**Business Unit:** Electronics **PCN/17/014/C+N-US**  
**Product range:** SCRJ POF Products Date: 2017-08-31  
**Title:** SCRJ POF Tool Improvement of Cutting System Page 1/2

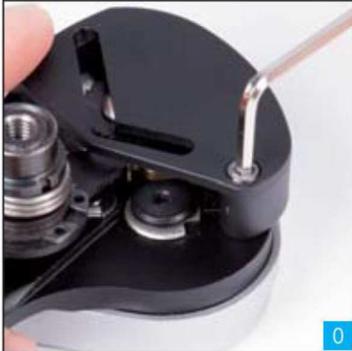
All safety-cutting devices are supplied with an additional protective device (safety cover for cutting blade). This protection will increase work safety and decrease the risk of injury from the cutting blade. The cutting device is now designed for a capacity of 2500 cuts per cutting blade (the safety cutting device blocks automatically). The old cutting device had a maximum number of 1260 available cuts.

The use of the protective device without a change of this device by the manufacturer is not possible for SCRJ POF tools manufactured before May 2017. Therefore, the protective device needs to be removed prior to assembly with hexagon socket screw key 1.5mm (see photo 0). See the instruction manual below.

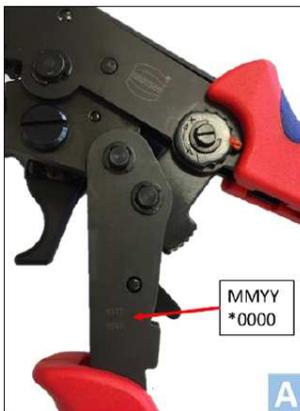
Production date of SCRJ POF tool can be identified by checking the marking on the tool under the shell type handle. Therefore, please pull shell type handle from the tool carefully to view the date code. Please see picture A.

May 2017 = 0517
